**PLANNING DIRECTOR'S SPECIAL PERMIT
FOR SINGLE FAMILY RESIDENTIAL IN A PUD**

FILE: P99-146

PROJECT NAME: Northpointe Park Village 11

TYPICAL STREETSCAPE PLAN

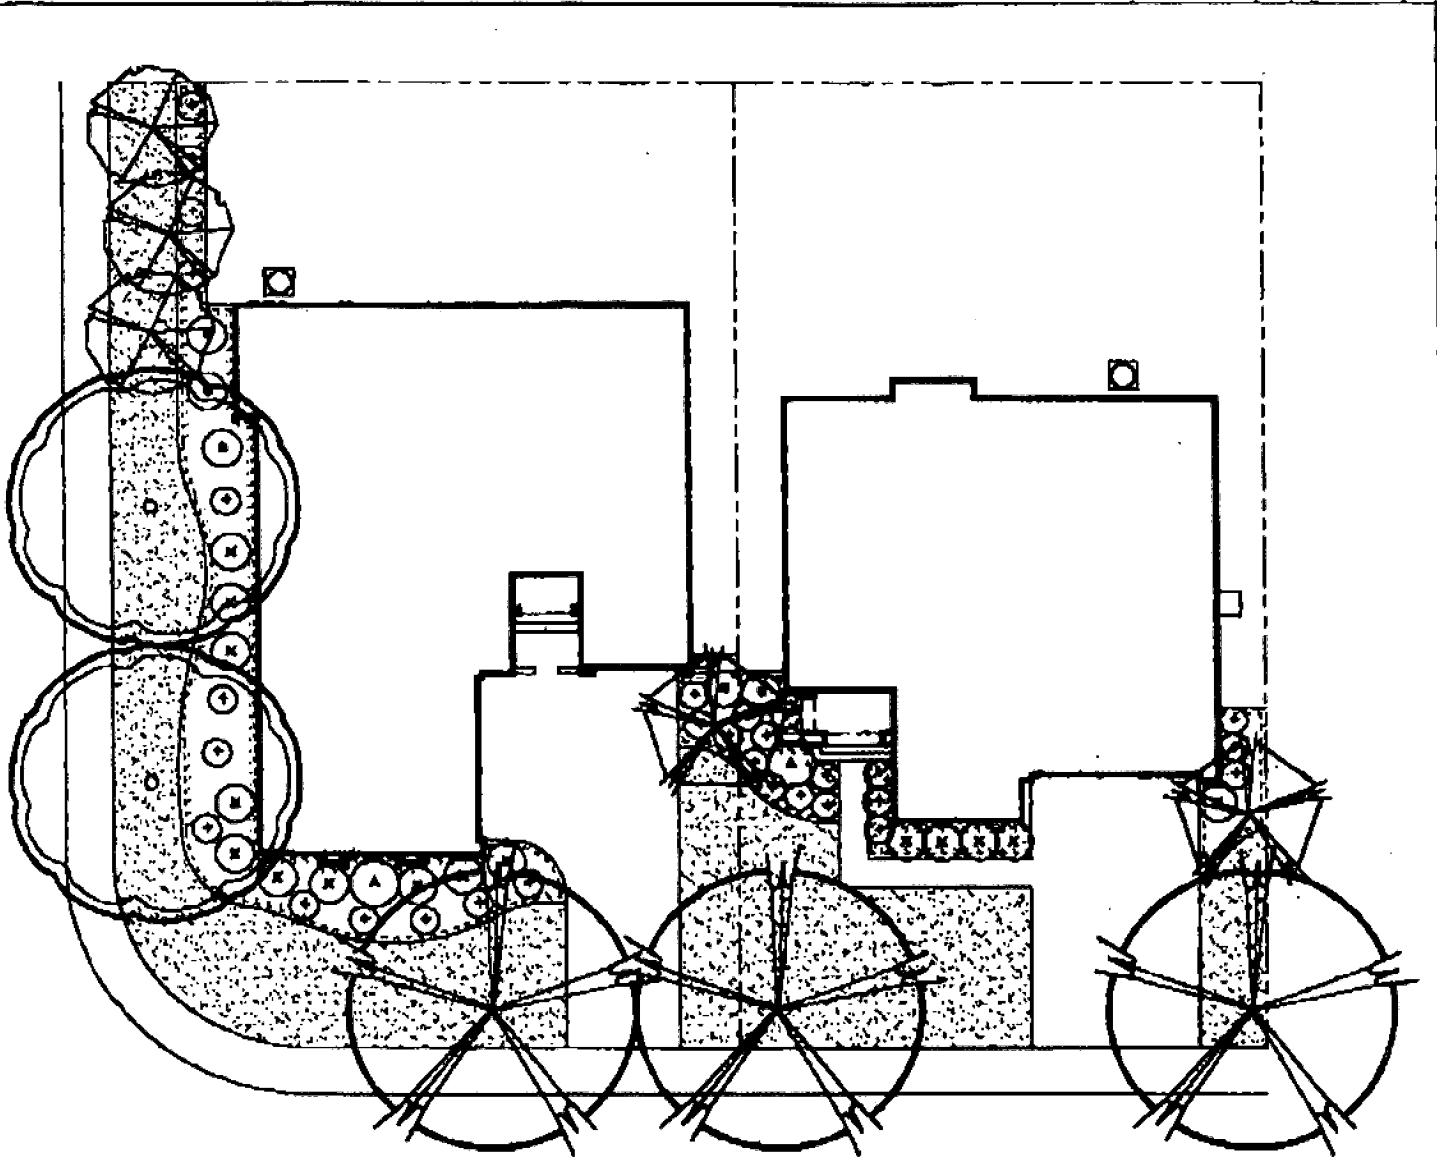
Landscaping: Exhibit 3 illustrates the typical landscaping plan. Approximately two street trees per lot are required on street frontage, at an average spacing of 20 to 30 feet on center. Also, each corner lot will be planted with two street trees at 20 to 30 feet on center and three accent trees. The street trees are shown on the diagram in the Natomas Park Design Review Handbook and accent trees are listed in the Recommended Plant Material List in the Northpointe Park PUD Guidelines. Front yard landscaping materials shall include, in addition to the street trees: one 15-gallon accent tree, one 5-gallon specimen shrub, 20 1-gallon foundation and accent shrubs, ground cover with a minimum spacing of 12 inch on center with decorative bark, and turf. Side yard landscaping shall include, in addition to the street and accent trees: one 5-gallon specimen shrub, ground cover with minimum spacing of 12 inch on center with decorative bark, and turf. Plant materials shall be selected from the plant list in the Northpointe Park PUD Guidelines Exhibit 12 or in the Natomas Park Design Review Handbook Figure VII-1, page 43.

8. Landscaping: Front yard landscaping materials shall include, in addition to the street trees: one 15-gallon accent tree, one 5-gallon specimen shrub, 20 1-gallon foundation and accent shrubs, ground cover at a maximum spacing of 12 inch on center with decorative bark, and turf. Side yard landscaping shall include, in addition to the street and accent trees: one 5-gallon specimen shrub, ground cover with a maximum spacing of 12 inch on center with decorative bark, and turf. Plant materials shall be selected from the plant list in the Northpointe Park PUD Guidelines Exhibit 12 or the Natomas Park Design Review Handbook Figure VII-1, page 43. All planting shall conform to City standards for sight line requirements at intersections and driveways. See Exhibit 3 for the Typical Lot Landscaping plan.

TYPICAL STREETScape PLAN

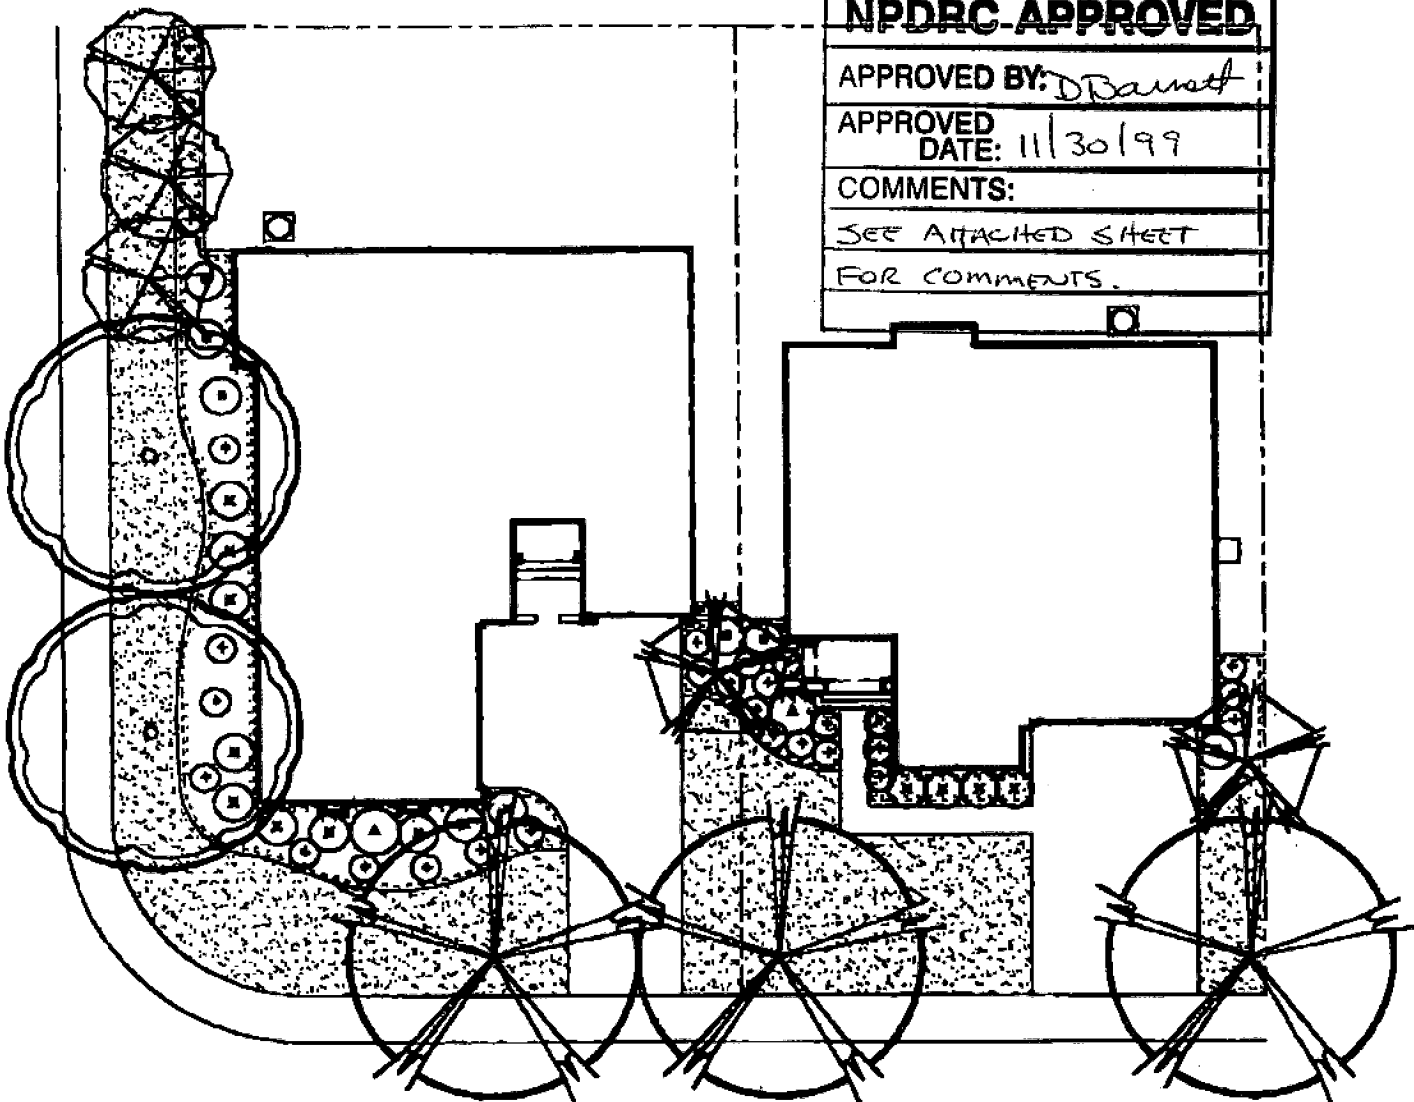
SEE ATTACHED SHEET FOR COMMENTS.

Landscape Plan Comments- JTS Northpoint 11

- 1) See Street Tree Species Plan (pages 35-36 of Builders Design Guidelines) for specific species of street trees required.
- 2) Plant materials to be consistent with Recommended Plant Materials List in Builders Design Guidelines.
- 3) Fence design and materials shall be consistent with pages 28-29 of Builders Design Guidelines.
- 4) Corner side yard fence shall be set back a minimum of 10 feet from sidewalk.
- 5) Quantity and size of plant materials shall be consistent with Builders Design Guidelines.
